This acknowledges receipt of your fax dated January 11, 1997, in which you state that as of January 10, 1997, you have ceased efforts to retrieve two lost well logging sources lodged in a 6,082' well. Your fax additionally requested approval to implement the plugging procedure detailed in your communication.

By this letter, formal approval is granted to implement the plugging procedure detailed in your communication of January 11, 1997 and to remind you of the reporting requirements contained in 10 CFR 39.77 and the placarding requirements of 10 CFR 39.15.

The fishing operations for our logging tools and RA sources have ceased as of 01/10/97. It has been determined (after due diligence) that they can not be recovered. The following plugging and cement procedure is submitted for your approval.

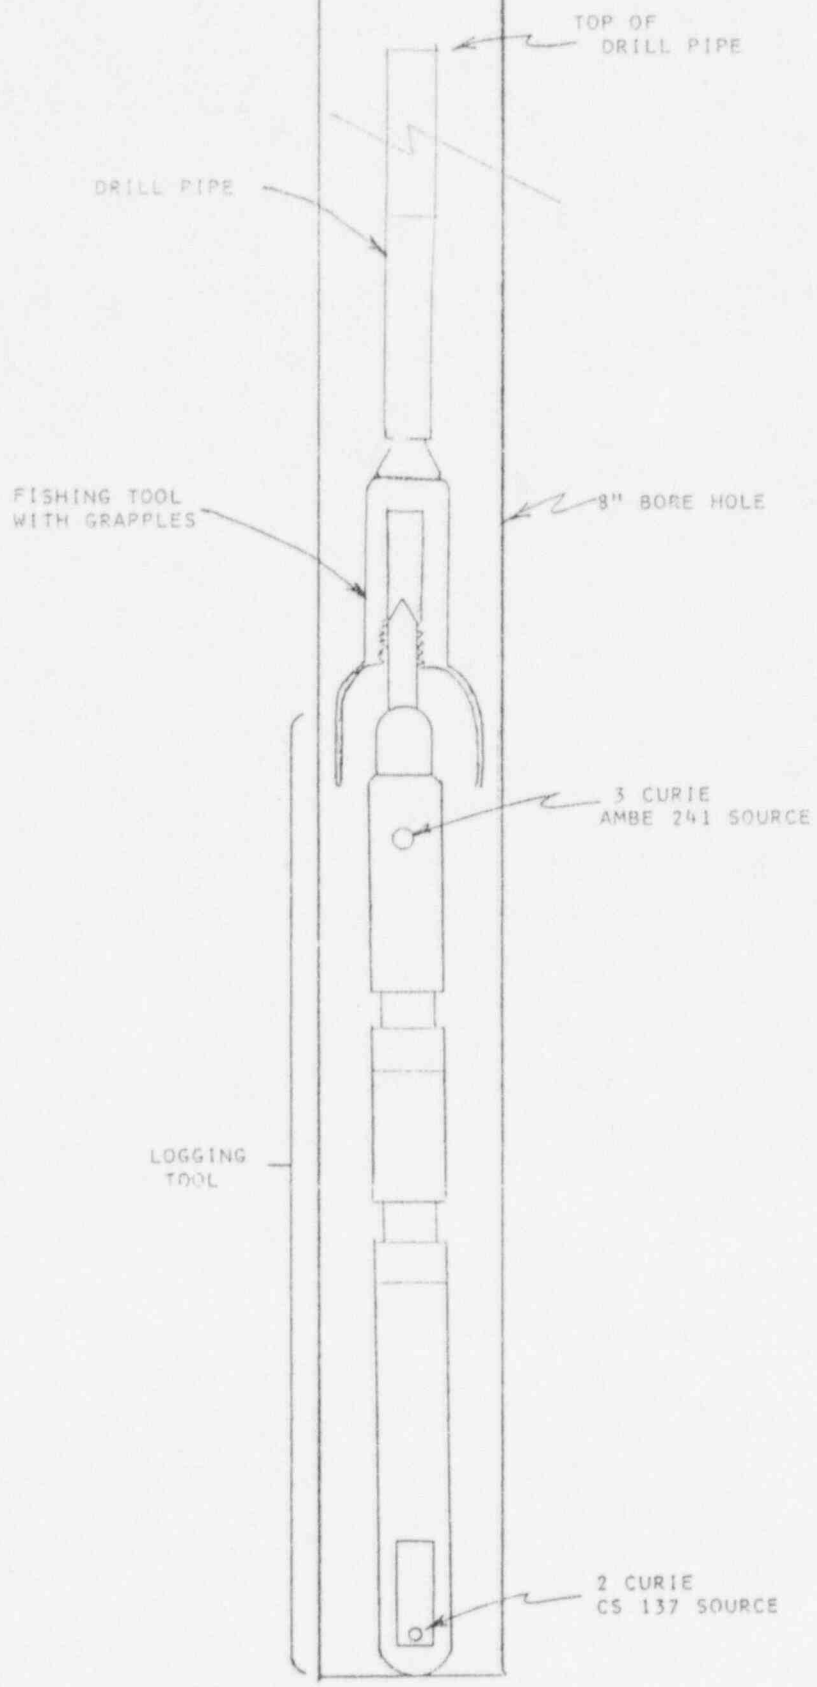
Total depth of Well --- 6,082', Bottom of tools --- 6,052', Top of fish --- 5,912'. All of fish is to be covered with colored cement to a depth of 5,750'. The well will then be plugged to surface according to State of Ohio plugging procedures and specifications. (see enclosed diagram)

FIGURE 4

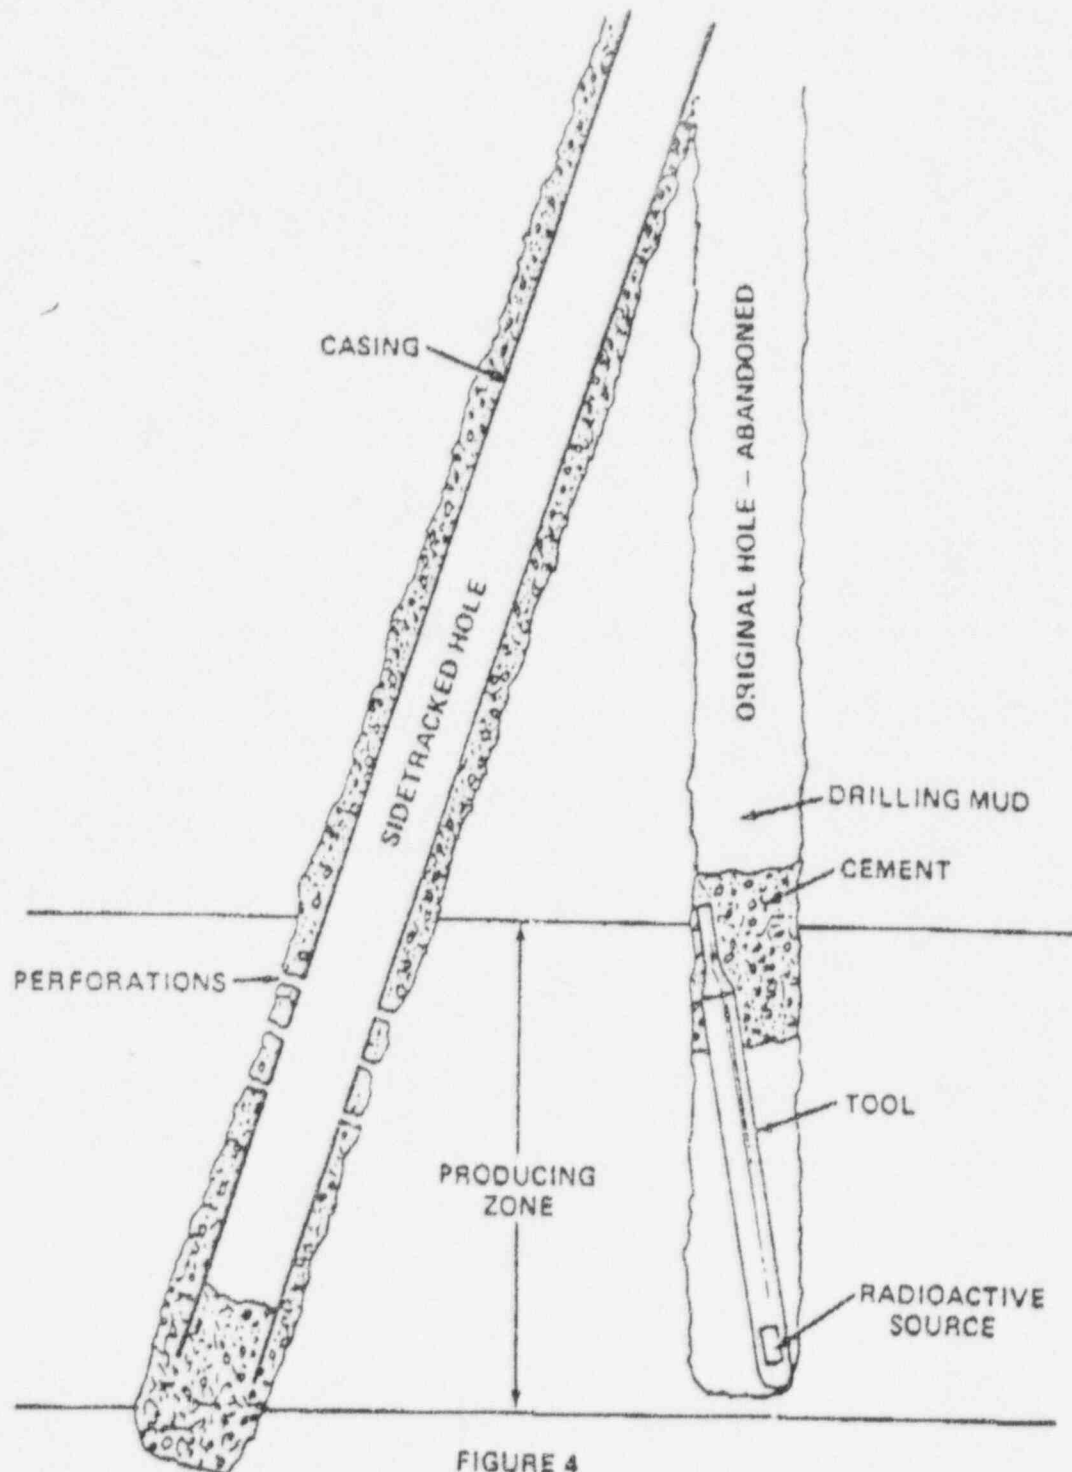
The well will then be placarded with a permanent metal plate to indicate the Isotope, source strength, depths and lowest plug depth not to be penetrated. (see enclosed sample)
